CHANGE ORDER NO.: 1

Owner:	City of San Luis	Owner's Project No.:	2025-050
Engineer:	PACE	Engineer's Project No.:	B777
Contractor:	Filanc	Contractor's Project No.:	
Project:	West WWTP 3.0 MGD MBR Upgrades		
Contract Name:	West WWTP 3.0 MGD MBR Upgrades		
Date Issued:	June 24, 2026	Effective Date of Change Order:	June 24, 2026

CHANGE ORDER REQUEST

CHANGE ORDER TITLE: Potential Scope Adjustment Options

SEQUENCE SITE PLAN
SCALE: 1/16" = 1'-0"

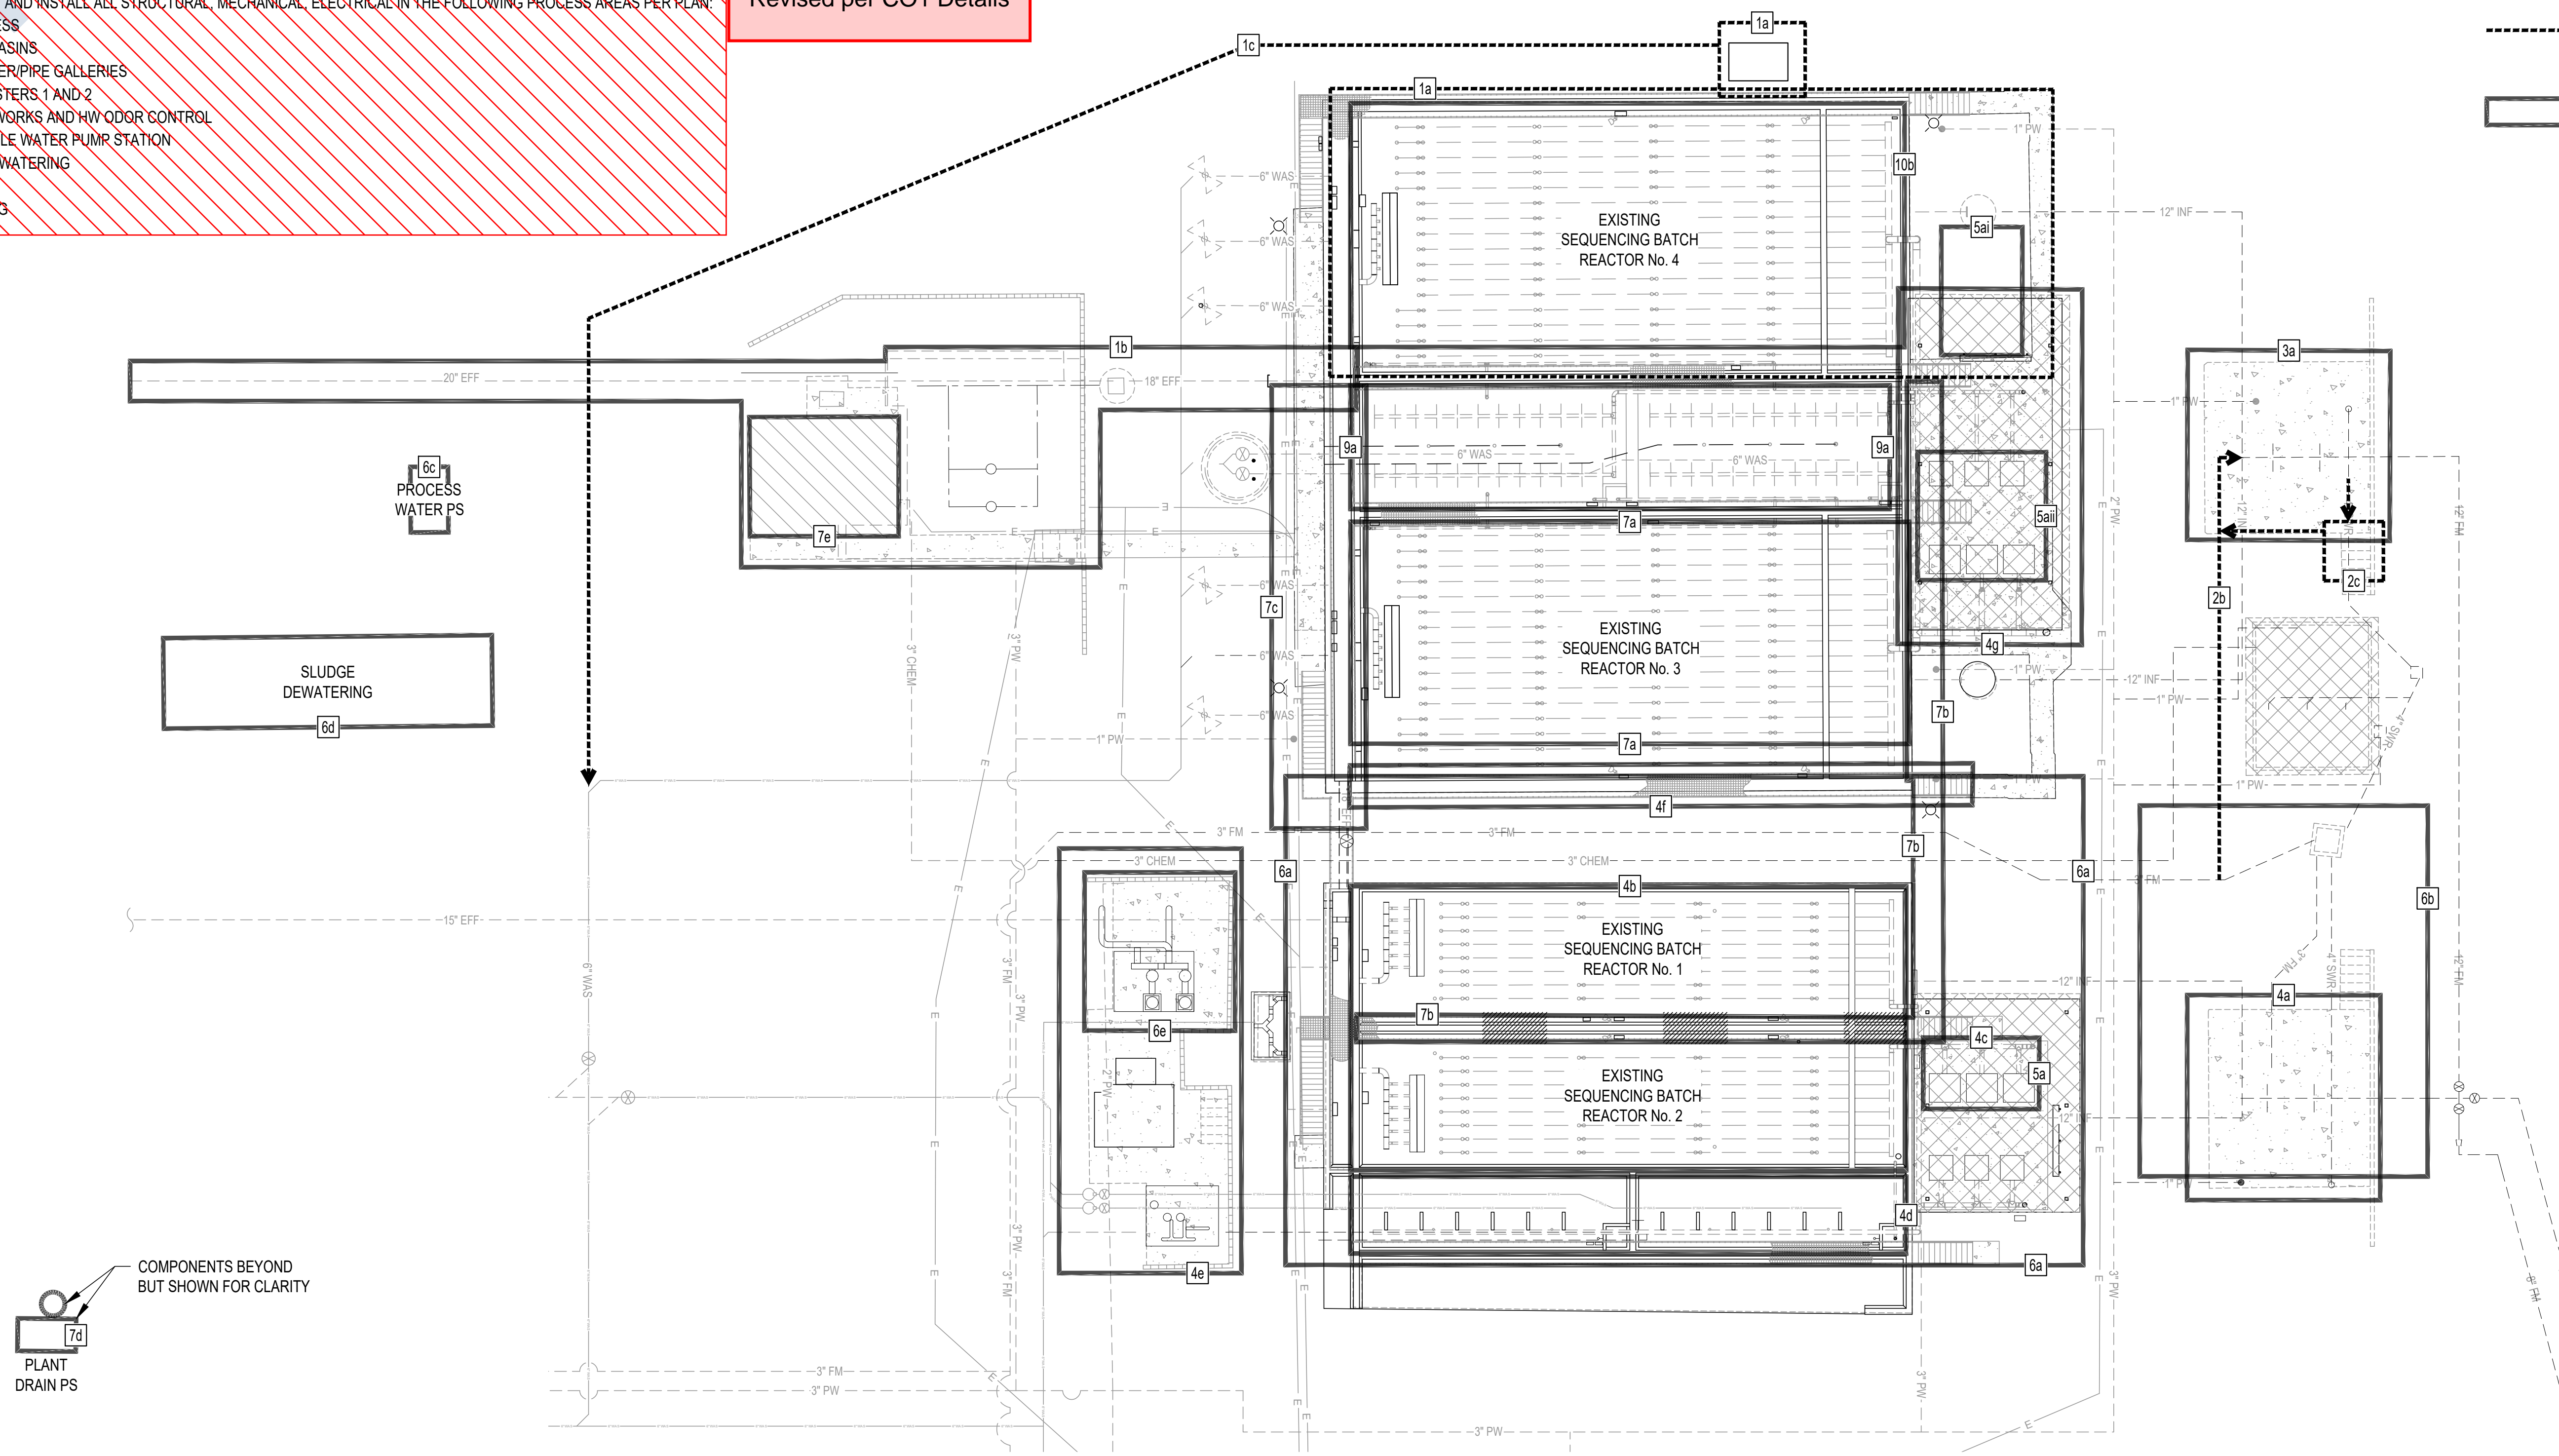
Revised per CO1 Details

- 1) Headworks will be relocated and brought online
- 2) Basins 1 and 2 will be isolated and Basins 3 and 4 will continue to operate
- 3) Filanc will complete the work in Basins 1 and 2, the new headworks, and as much of the MLSS channel as possible.
- 4) Concurrently we will make all necessary modifications, install, and startup the intensification unit To be operational prior to beginning work in basin 3
- 5) Once intensification is complete Filanc will complete work in basin 3 and begin the commissioning process of the headworks, basins 1, 2, and 3, MLSS Channel, and all other support systems making the MBR operationally complete.
- 6) Upon completion of MBR commissioning Filanc will remove intensification system and complete the modifications of Basin 4 to an Equalization Basin. Completing the project.

**MBR UPGRADES
PLAN - LEVEL 3**
SCALE: 1/4" = 1'-0"

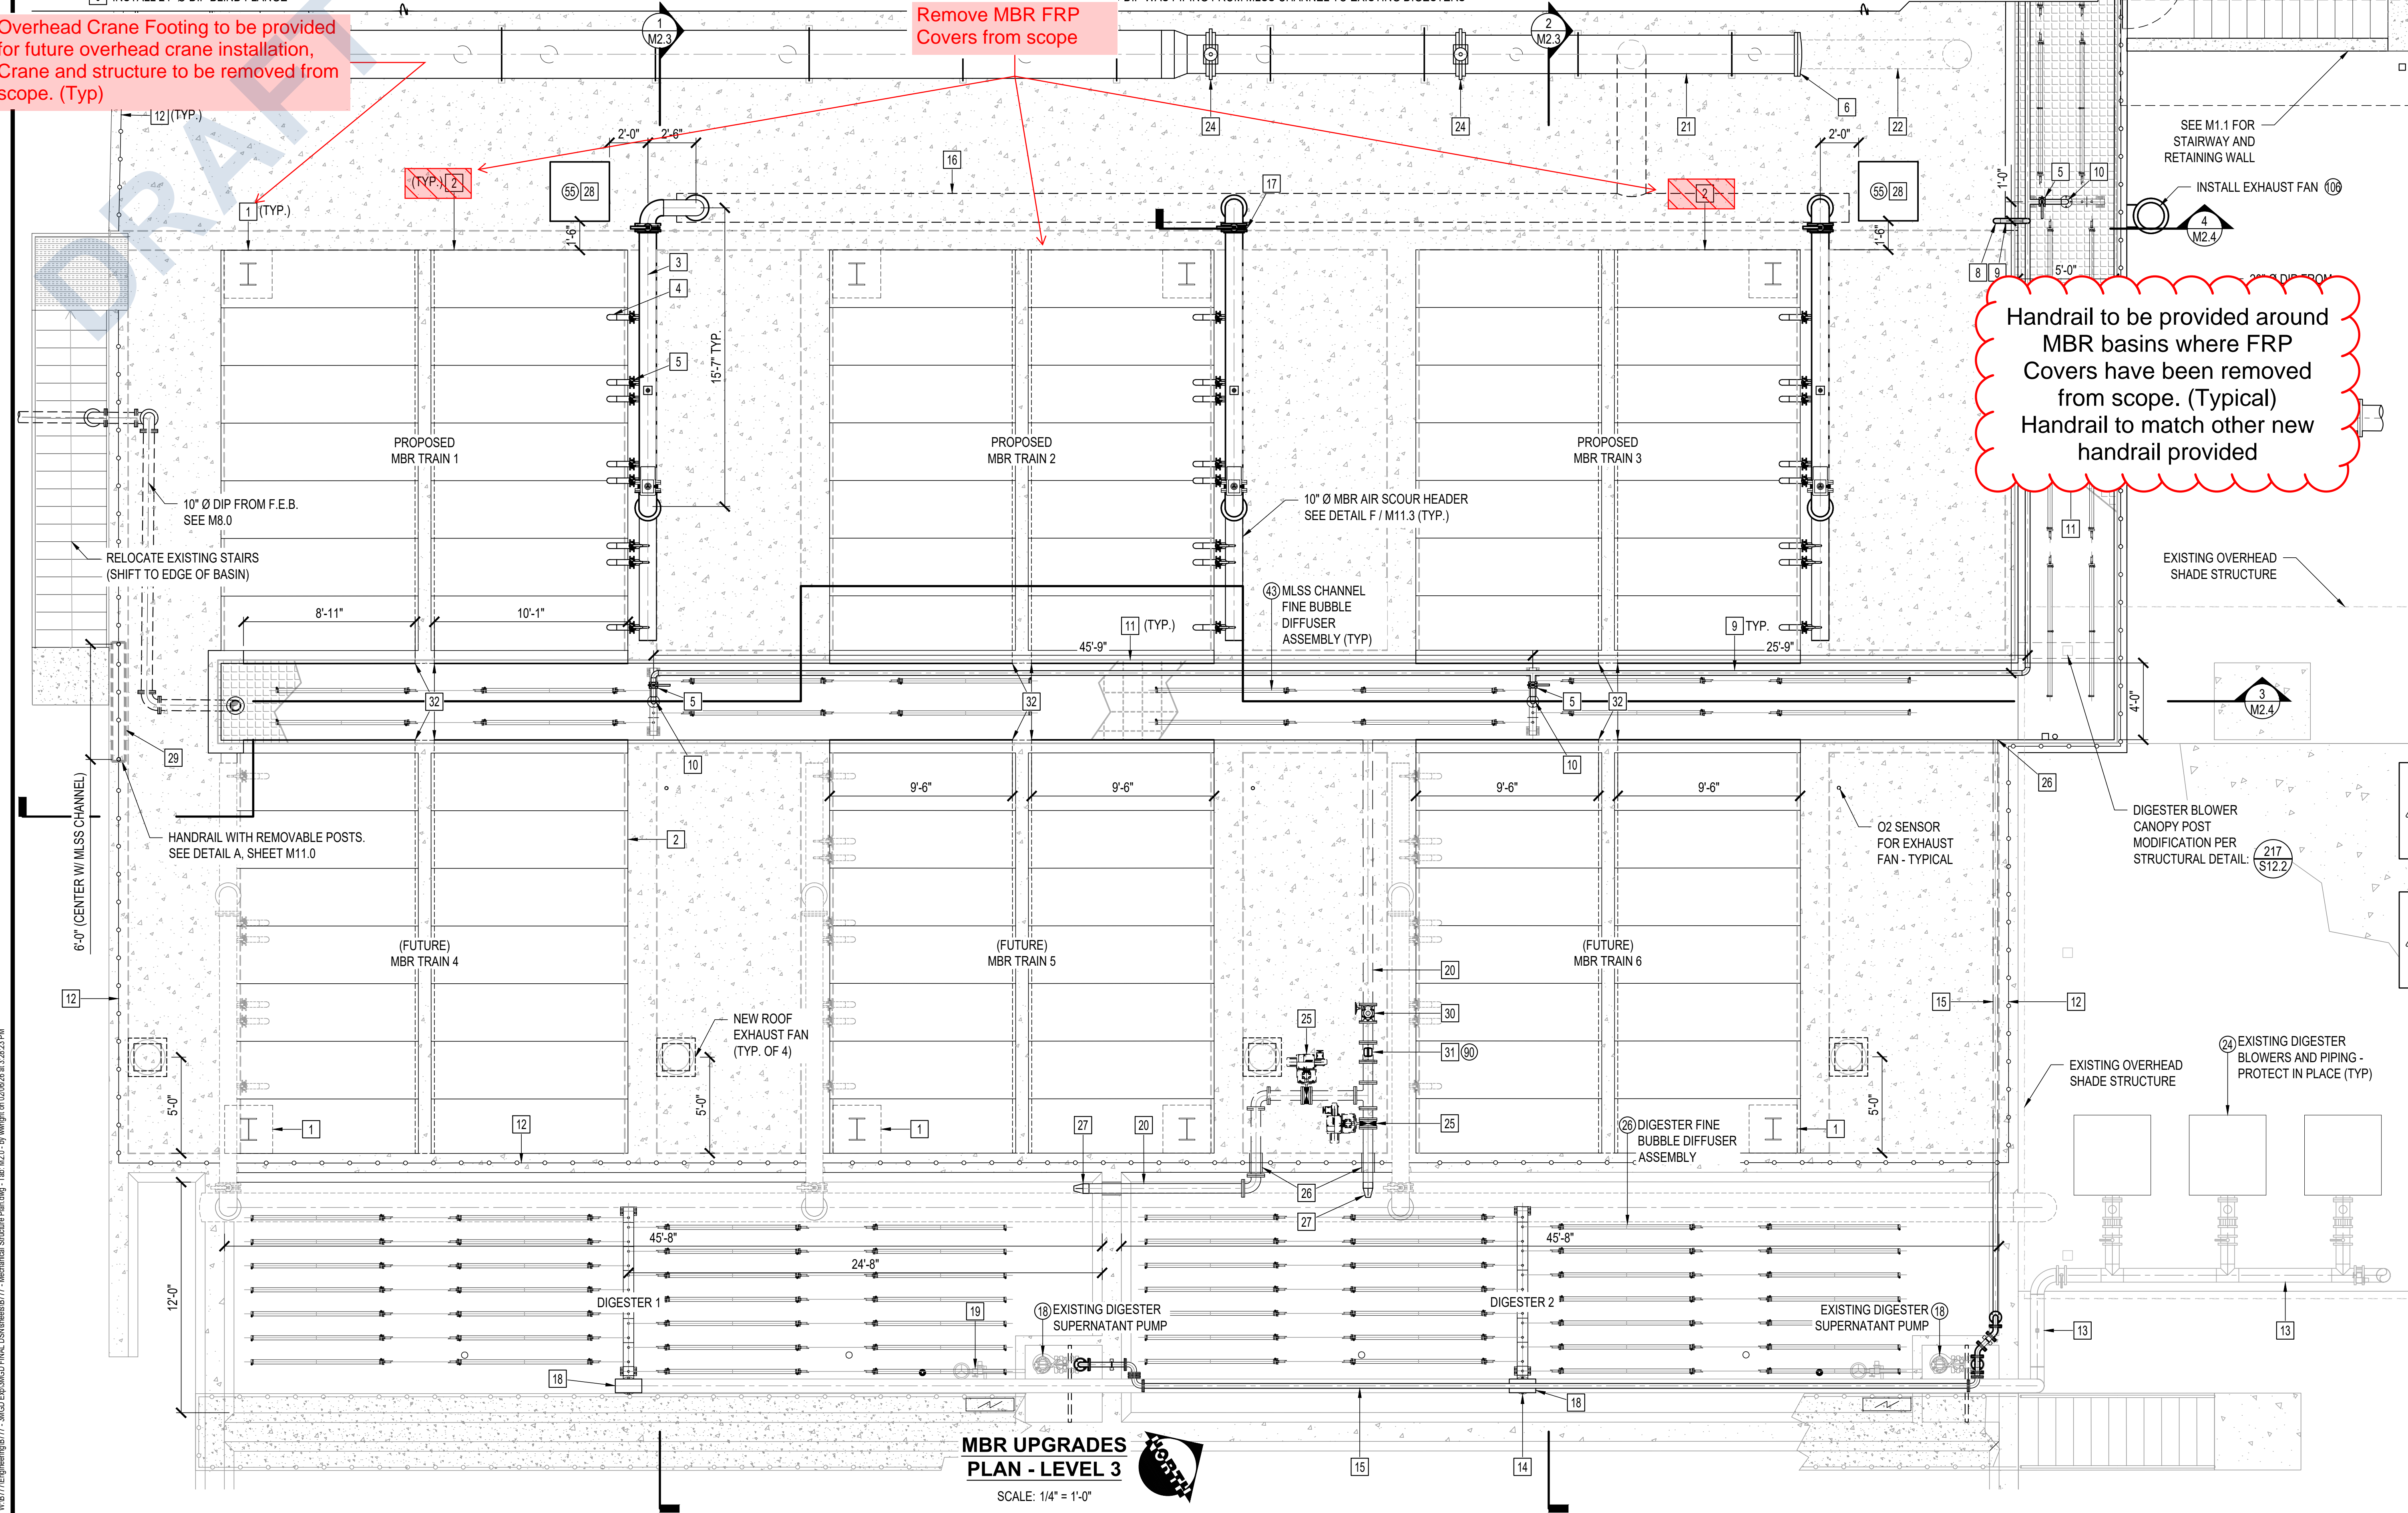
Overhead Crane Footing to be provided for future overhead crane installation, Crane and structure to be removed from scope. (Typ)

Remove MBR FRP Covers from scope

Handrail to be provided around MBR basins where FRP Covers have been removed from scope. (Typical) Handrail to match other new handrail provided

- Remove from scope: MBR FRP covers over the MBR basins shown on Sheet M2.0, Note 2.
- Remove from scope: MBR overhead crane structure shown on Sheet M2.3 (Note 1) and S2.2. Footing shall be provided as detailed in the structural plans for future overhead crane.
- Remove from scope: MBR overhead crane shown on Sheet M2.0 M2.3, M2.4
- Provide additional handrail in lieu of FRP covers at the MBR basins. Handrail to match other new handrailing provided in other areas as specified in project specifications and Sheet W11.0 Detail D.
- Remove from scope: Structural submittal requirements associated with the deleted structural scope items above.
